Errata Sheet

Rel. 2.2, 2011-10-10

Device	**TC1796**
Marking/Step	**EES-BC, ES-BC, BC**
Package	**P-BGA-416, PG-BGA-416**

This Errata Sheet describes the deviations from the current user documentation.

Figure 1

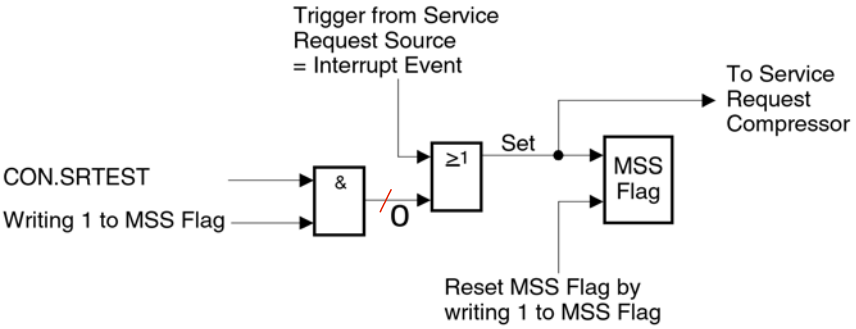
ADC_TC.023 Setting the MSS-flag doesn't generate an interrupt in TEST-MODE

It is possible to generate a software triggered interrupt event in TESTMODE (ADCx_CON.SRTEST=1) by setting one of the bitflags in register ADCx_MSS0/1. Due to the fact, that this mechanism is not working, it is not possible to generate a corresponding interrupt by software.

Figure 3 Timing concerning equidistant multiple timers

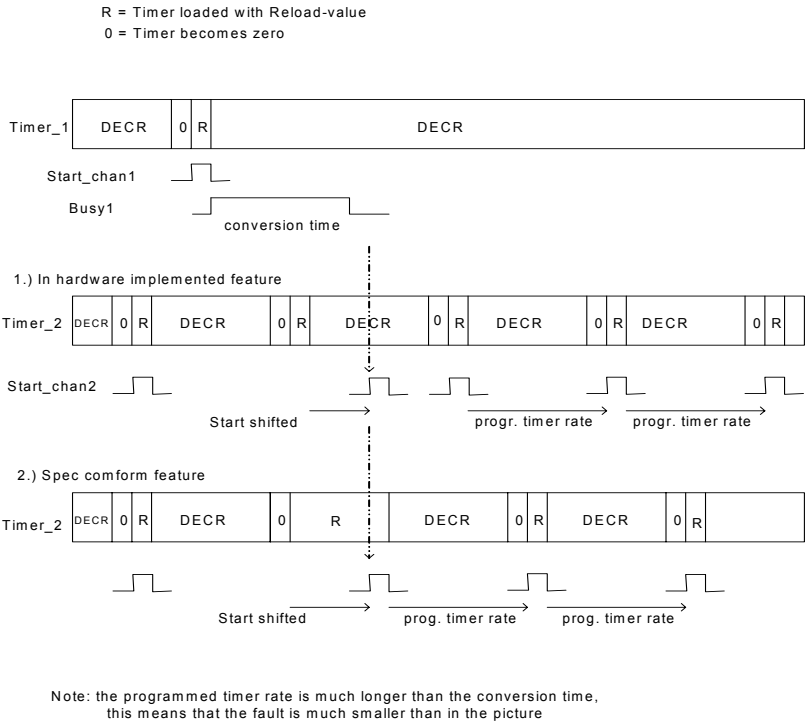
The correct behavior would be a reload when the requested conversion (of channel_2) is started.

Therefore the start of conversion for channel_2 is delayed by maximum one conversion-time. After this delay it will be continued with equidistant conversion-starts. Please refer to the following figure.

Figure 4

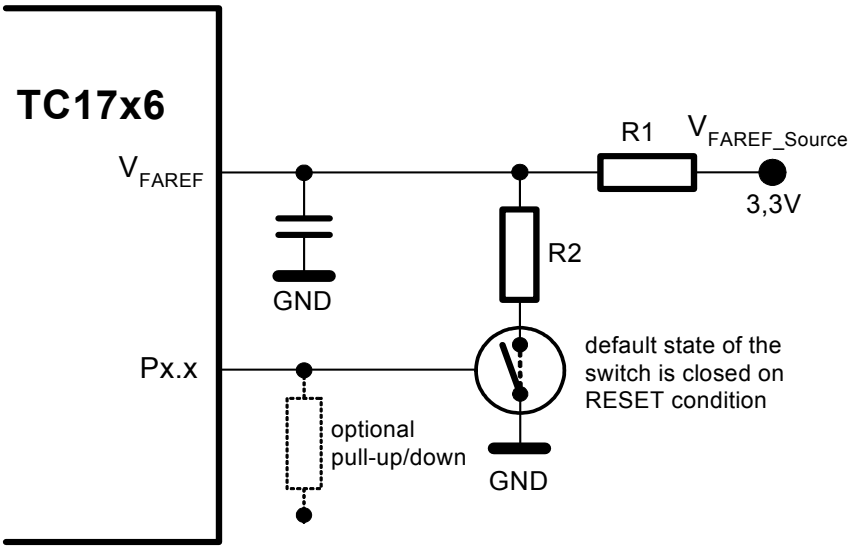
Stress minimization over lifetime can be achieved by the introduction of a small external circuitry applied to the V_{FAREF} pin. The circuitry might consist e.g. out of a switchable voltage divider applied to V_{FAREF} pin, which as default in any reset condition of the device assures voltage levels between 0 V to 1.65V.

Figure 5 Uncritical transmission

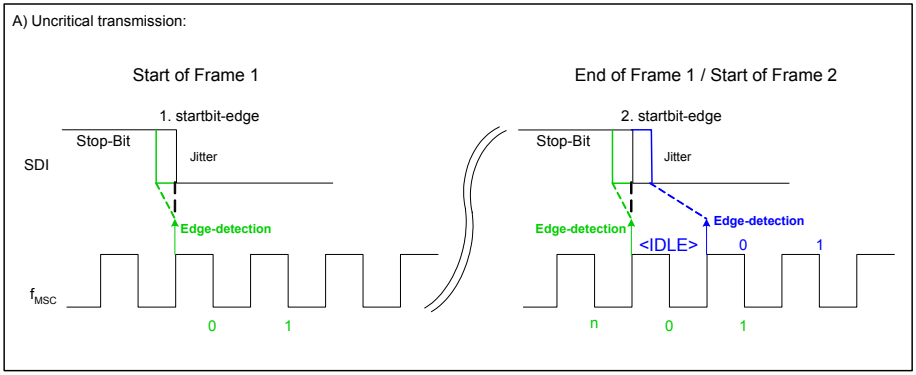
As the falling startbit edge is shifted to the left of the rising clock edge (**Figure 5** left), there occurs a secure detection of the next start-bit edge in the last cycle of the previous frame (here cycle n, **Figure 5** right) independant from the applied jitter to this edge.

Figure 6 Critical transmission

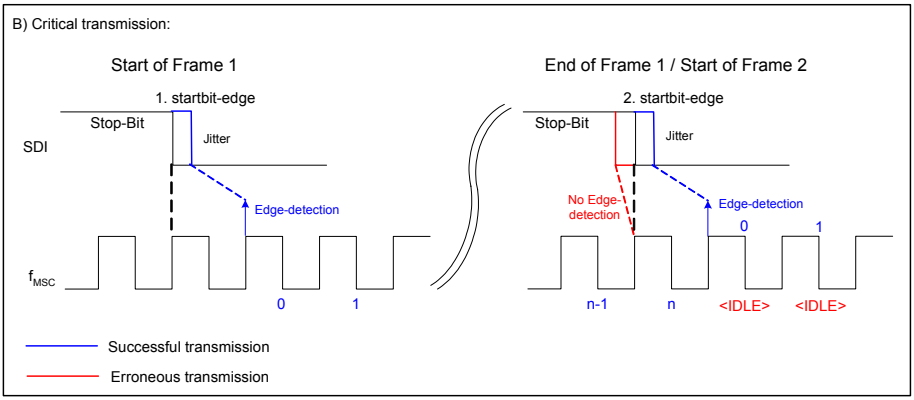
If the high-low edge of the start-bit in the first frame is just not detected by the near clock-edge (**Figure 6** - left) and the start-bit edge of the second frame is jittering to cycle n-1 (**Figure 6** - right, red coloured), then an erroneous transmission will take place. In this case the state-machine switches to IDLE after the last state n and wakes up on the next falling edge that may be a data-bit recognized as a start-bit. If the start-bit of the second frame is jittering to cycle n (**Figure 6** - right, blue colored), then the state-machine will not switch to IDLE but will start receiving the next frame correctly.

Figure 7 Delay adjustment relative to the module clock

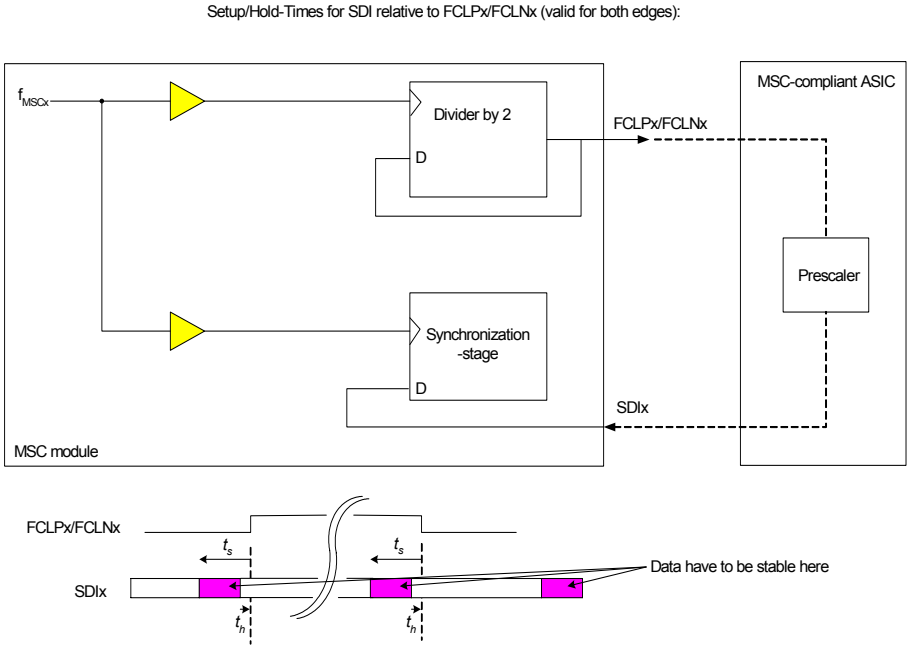
Figure 7 shows the principle blockdiagram of the input synchronization stage of the MSC module.

The delay depends on the maximal skew in the data-stream. For this workaround the downstream clock FCLPx/FCLNx can be measured as reference and the data stream at the input of the upstream channel SDIx has to be adjusted according to the setup- and hold-times of the input-pins SDIx.

Figure 10

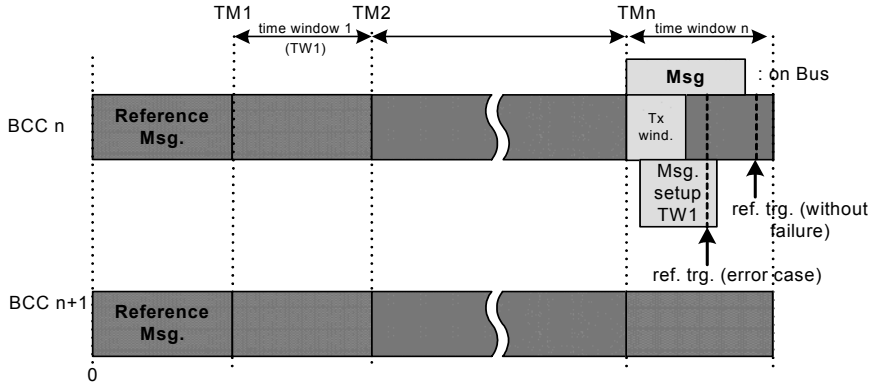
MultiCAN_TC.036 Wrong message may be sent during reference message trigger in a gap

The TTCAN controller is configured as timer master, gap mode has been selected and no message is transferred (reception or transmission) after the transmit enable window in the last time window. With the end of the transmit enable window, the TTCAN logic starts waiting for a reference message trigger to send a reference message. At the beginning of each time window, the TTCAN logic evaluates the scheduler entries for the following time window and prepares the setup of the corresponding message for the next tranfer window. If the reference trigger becomes active after the end of the transmit enable window, but still during the setup phase, the prepared message will be sent out instead of the reference message. After this erroneously sent message, the reference message will be sent out correctly. The error does not occur if the reference trigger becomes active after the end of the setup time.

Figure 12 Current accuracy range

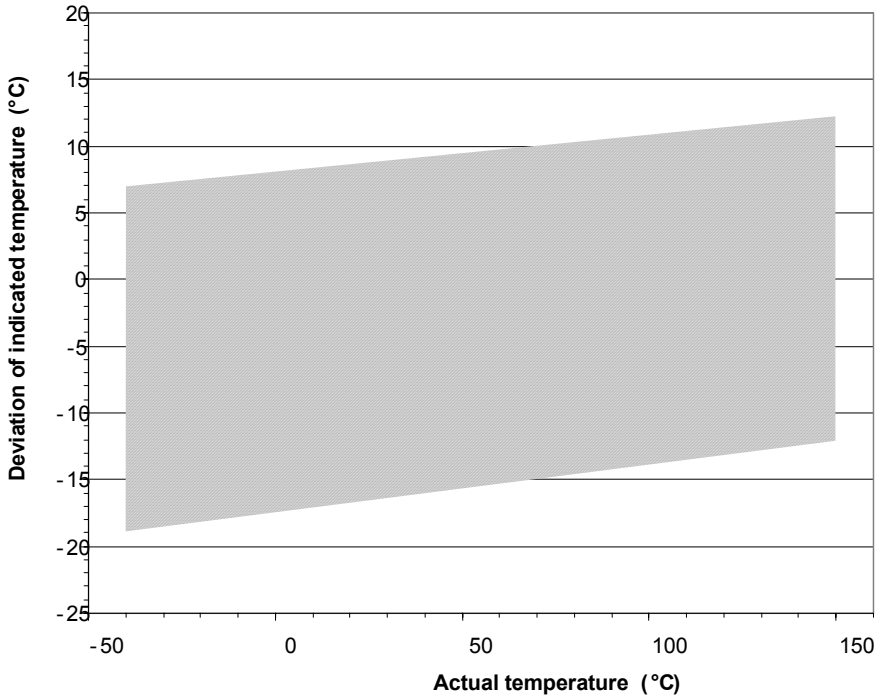
The deviation using these formulas is:

- +/-12°C at T_J = 150°C
- +9/-17°C at T_J = 25°C
- +7/-19°C at T_J = -40°C

Figure 15 Exemplary power-up/down sequence

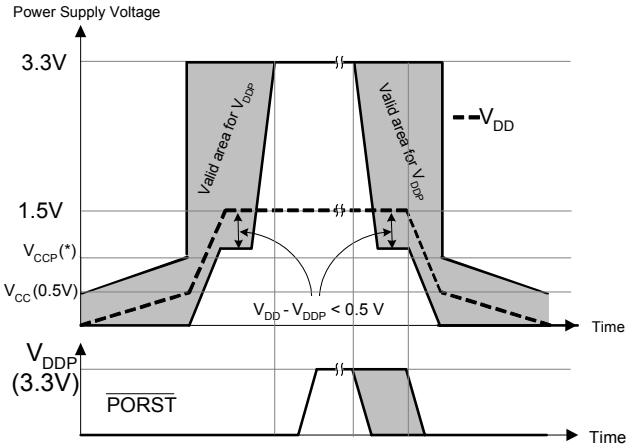
As per Data Sheet, V_{DD} - V_{DDP} < 0.5 V has to be valid at any time in order to avoid increased latch-up risk. The figure below shows the possible V_{DDP} values as shaded region for an exemplary V_{DD} ramp. Moreover, the following rules apply:

- V_{DDEBU} and all analog voltages (V_{DDOSC3}, V_{DDM}, V_{DDMF}, V_{DDFL3}) must also follow V_{DDP} power-up/down sequence.
- V_{DDAF}, V_{DDOSC} must follow V_{DD} power-up/down sequence.
- The absolute value of the maximum allowed deviation between any two supplies is 0.5 V while the 1.5V supplies are below their specified operating conditions.

*Note: V_{CC} and V_{CCP} in **Figure 15** refer to devices with PWR_TC.P009 erratum.*

Figure 18

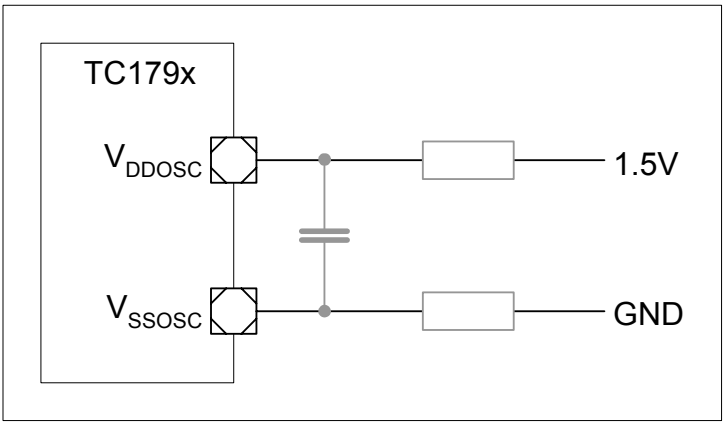
PLL_TC.H004 V_{DDOSC} and V_{SSOSC} bonding change

V_{DDOSC} and V_{SSOSC} silicon pads are not connected to their package balls, but V_{DDOSC} is connected to V_{DD} (core supply) and V_{SSOSC} is connected to V_{SS}, in order to reduce short-term jitter. Thus V_{DDOSC} and V_{SSOSC} package balls are unconnected. For future design improvements it is recommended to prepare the PCB like it is shown in the figure below. The capacitance and both resistors need not to be assembled on the PCB but they should be planned for values of about 10?F...100?F for the blocking capacitance and 0?...10? for the resistors.

Figure 19 Stand-by current at 125°C ambient

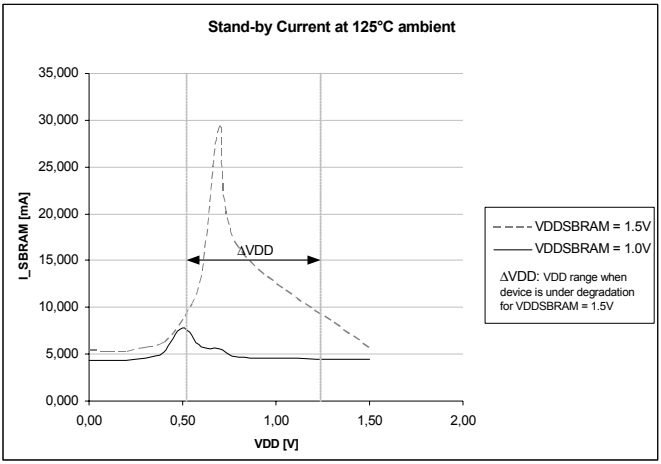
During transition from/to stand-by mode, while increasing or decreasing core power supply (V_{DD}), it may happen, due to cross-current, that I_{SBRAM} reaches high current values.

The worst case takes place when V_{DD} = $V_{DDSBRAM}$/2, specially if $V_{DDSBRAM}$ = 1.5 V (SBRAM power supply for normal operation). In this situation, I_{SBRAM} may reach 29.5 mA (hot at 125°C ambient).
